# 8-1. RELEVANCE OF PAIRED BORES USED FOR SITE CHARACTERISATION

This concern responds to the following SEARs for SSD 5765:

Figure 1: Paired well locations – adapted from Figure 23 of (Jacobs (Australia), 2020, pp. 5-88)

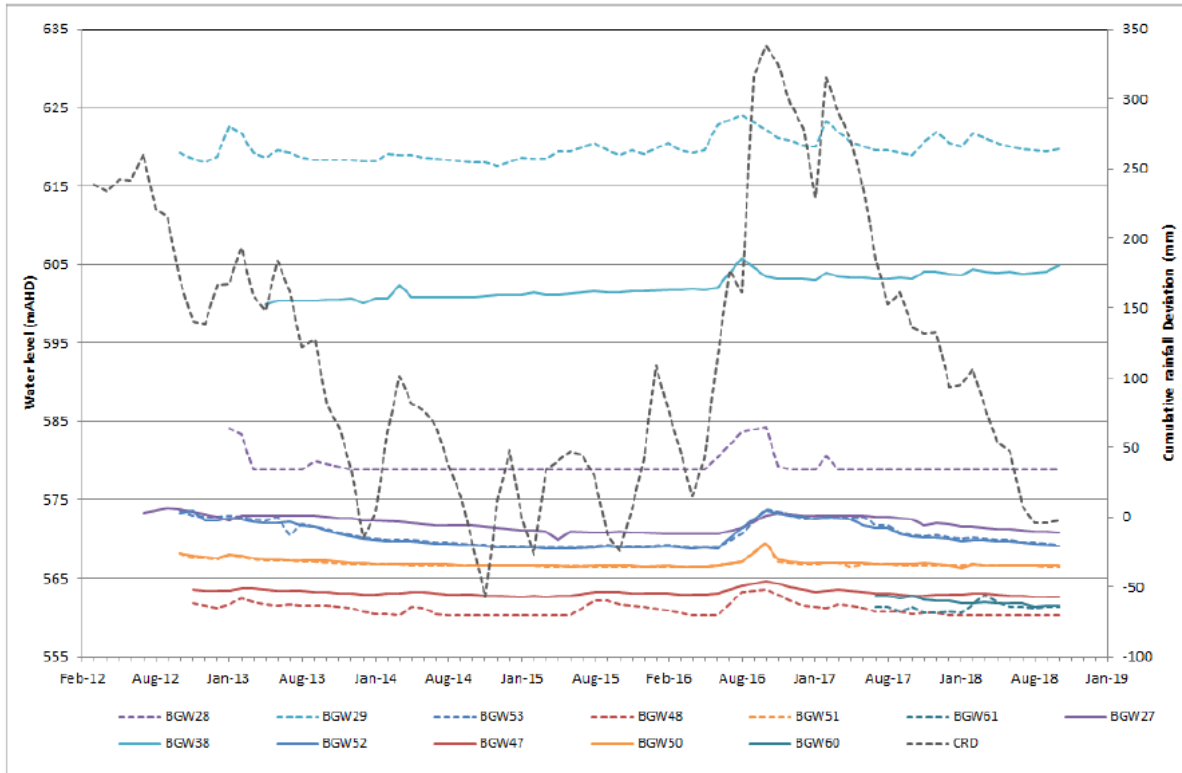
This raises two questions: are there sufficient investigation and monitoring bores to inform predictions? and how has this uncertainty been reflected in the outcomes of the EIS? Conclusions drawn in the EIS from available paired well data (Figure 1, Figure 2 and Figure 3) are queried below.

The KCN spring area (BGW29/38) shows resistance to flow across the 52 m separating the two screened zones (Table 1).

**Figure 2: Paired well hydrographs – Figure 27 in (Jacobs (Australia), 2020, pp. 5-94)**

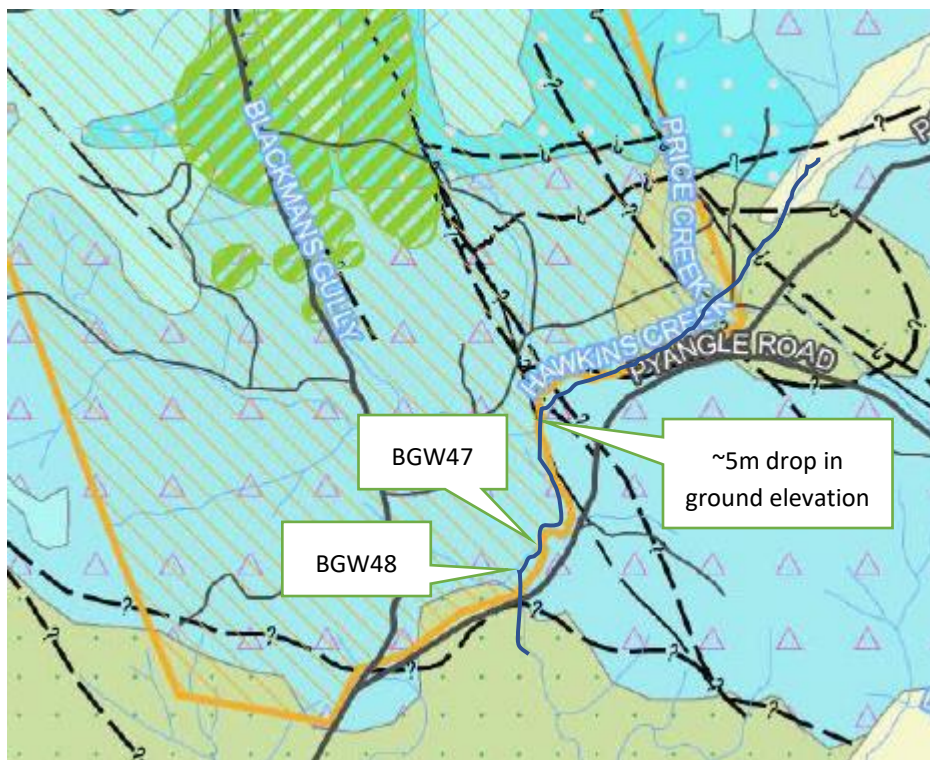
From July 2017 to January 2018, BGW60/61 (near the proposed TSF) showed evidence of some barrier to vertical flow. This resistance or barrier is not evident after January 2018.

Further evidence of why BGW47 and BGW48 should be regarded as 'paired' should be provided (they are 100 m apart alongside Hawkins Creek). There is no evidence of vertical barriers to flow from the data provided. Following is a brief discussion of the reason for this uncertainty that influences conclusions regarding the impact to Hawkins Creek. BGW47 and BGW48 are at approximately 566 mAHD, despite BGW48 being around 100 m downstream. Upstream from BGW47 (350 m), the ground elevation rapidly drops by approximately 5 m. Groundwater from this escarpment may provide the baseflow for Hawkins Creek. Aside from BGW28/27, there is no evidence of an extensive aquitard separating paired bores. BGW28 (0-6 m in the alluvium) shows a flat trend. On closer inspection of BGW28, (shown as the aqua colour trace on Figure 4), it appears that the lowest groundwater level is at the base of the screened interval (6 mbgl). If the BGW28 bore construction does not allow water to drain from below the screen, then the hydrograph is responding to a well construction artefact (as suggested in (Jacobs (Australia), 2020, pp. 5-95). If the well had been designed to allow water to drain, a drop of over 8 m during dry periods is possible, a level below the static water level (SWL) in BGW27.

**Figure 4: Groundwater hydrographs – adapted from Figure 26d in (Jacobs (Australia), 2020, pp. 5-93)**

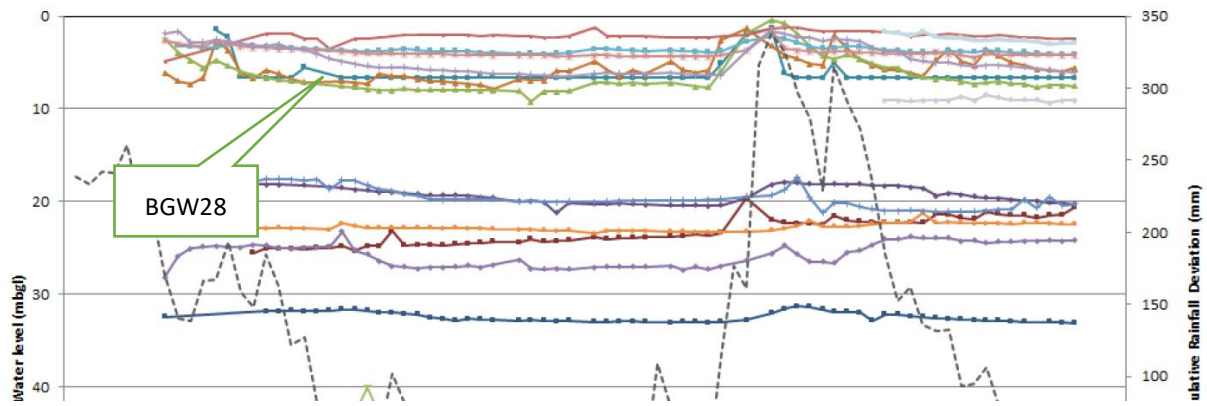
The Hawkins Creek hydrograph (in mAHD) would need to be compared against BGW48's hydrograph to clarify whether Hawkins Creek is losing or sustained by groundwater flows either near BGW48 or upstream.

Considering the above, more lines of evidence are required to strengthen any argument for a significant barrier to vertical flow in the region.
